ABWR

Subject Revised response to DSEB (SECY-91-235)
outstanding Issue 31

This is a revised response to DSER Open Item 2.31.

The attached markups show the changes to SSAR chapter 7.7.1.4 (9) (Interlocks) and Figures 7.7-8 and 7.7-9 to adopt this improvement. We plan to include these changes in Amendment 34.

Page 1 of Fig. 7.7-8

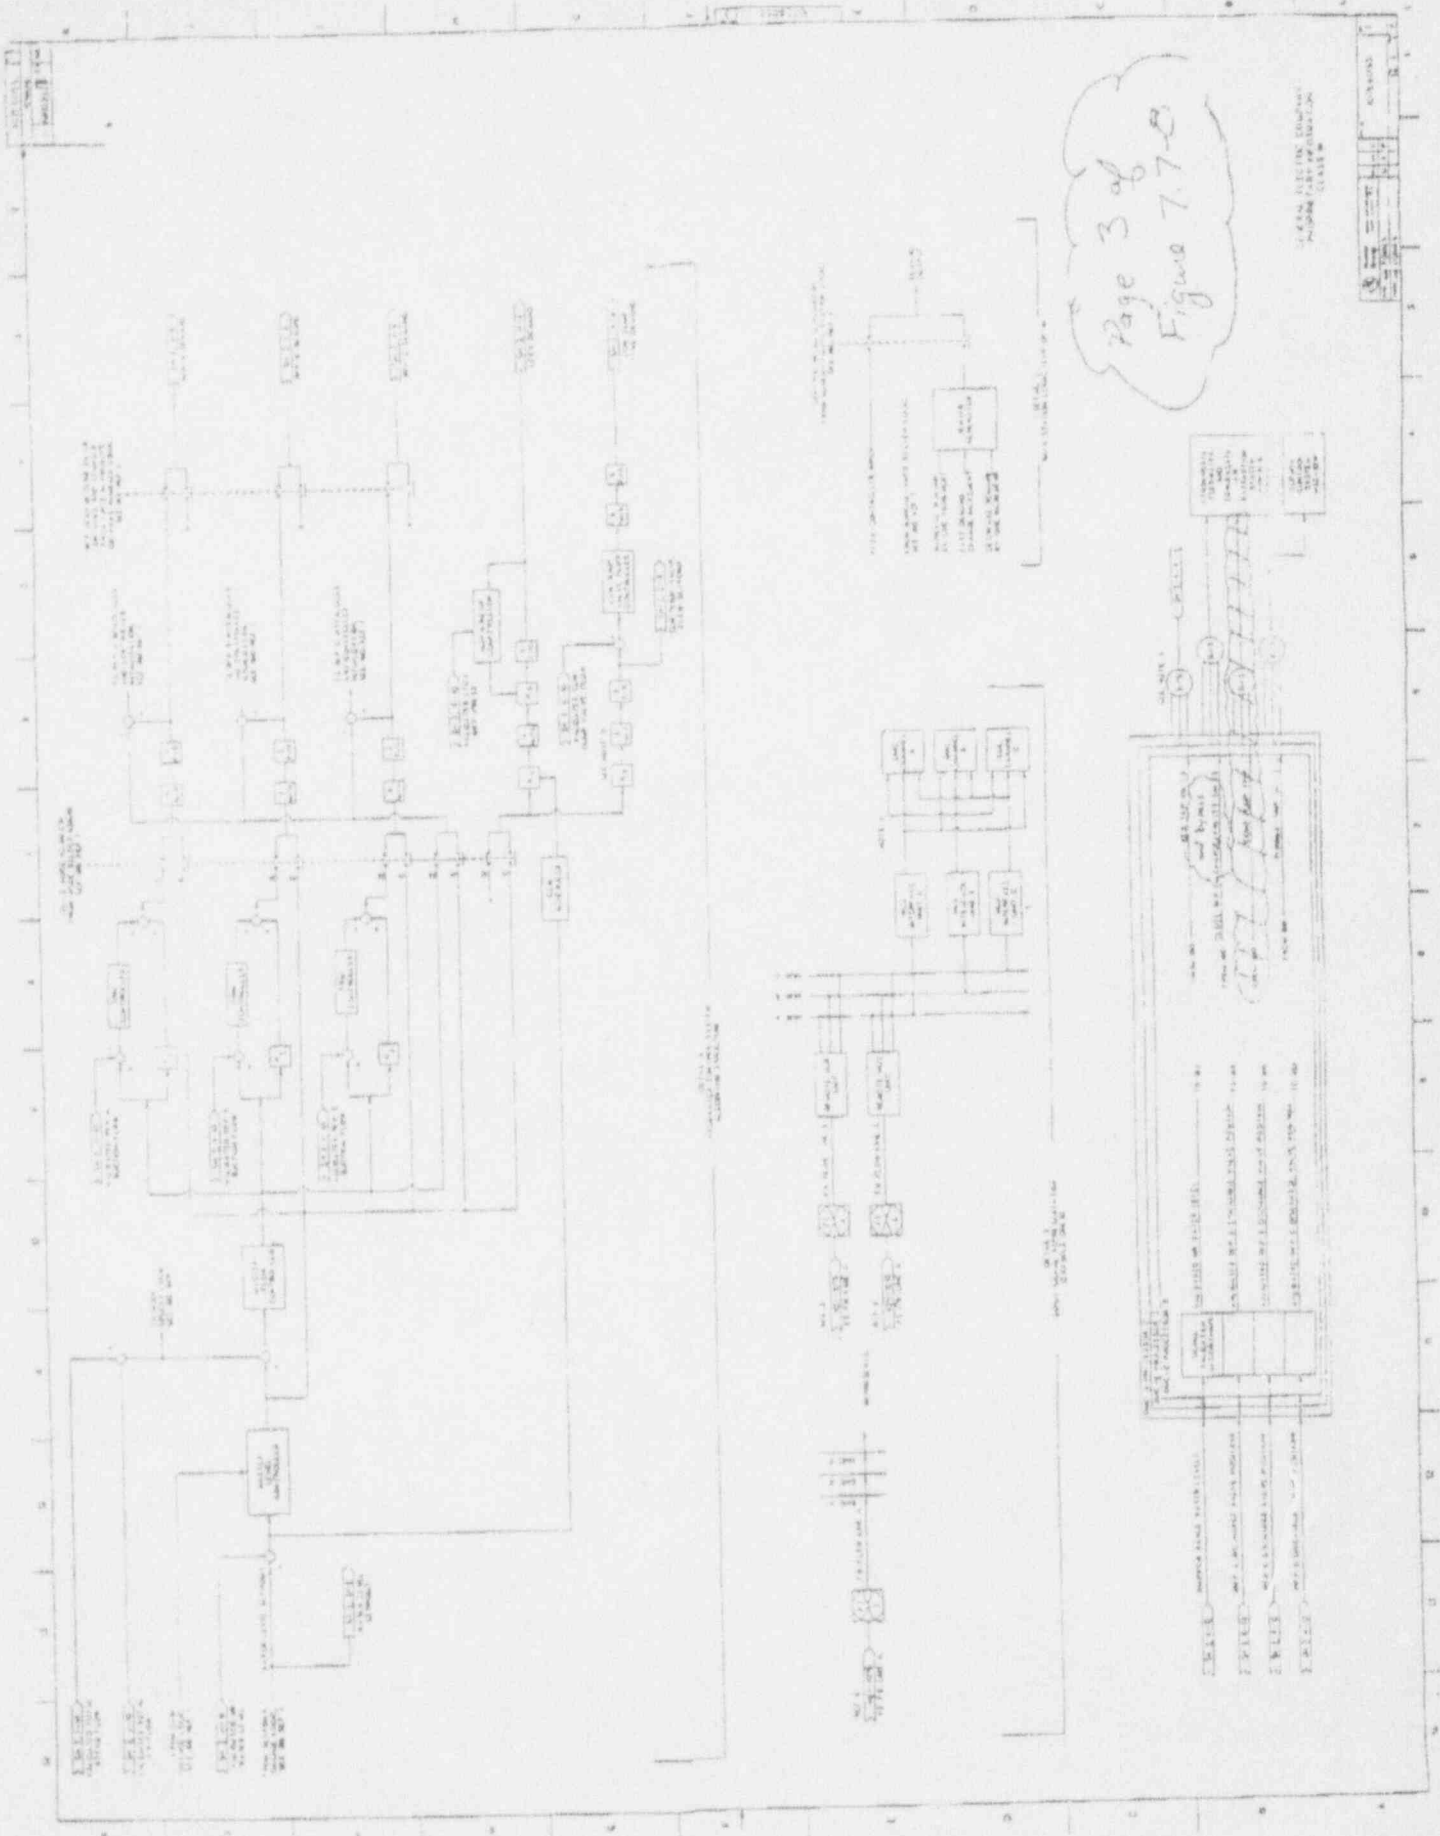
It was previously stated that the resolution to this issue was to trip the condensate pumps in the event of Level 8. In the SSAR this was further restricted to occur only if it was coincident with indication that the feedpump discharge valves were not fully closed. This solution imposes unreasonable restrictions on plant operation. From an operational standpoint, it is desirable to maximize the availability of the condensate pumps (short cycle cleanup mode to keep condensate in hotwell clean), even during shutdown periods, when a higher water level could be expected to be above Level 8.

The preferable solution is to close all feedpump discharge and bypass valves in the event of Level 8. This solution isolates the condensate pumps from the vessel, but allows them to remain available and operating for short cycle cleanup mode. It resolves the concern about vessel overpressurization by isolating the condensate pump from the feedwater piping sections in between the feedpump discharge valves and the feedwater injection valves. Therefore, even if the feedwater injection valves inadvertently open, the closed feedwater pump discharge and bypass valves prevent condensate flow to the vessel.
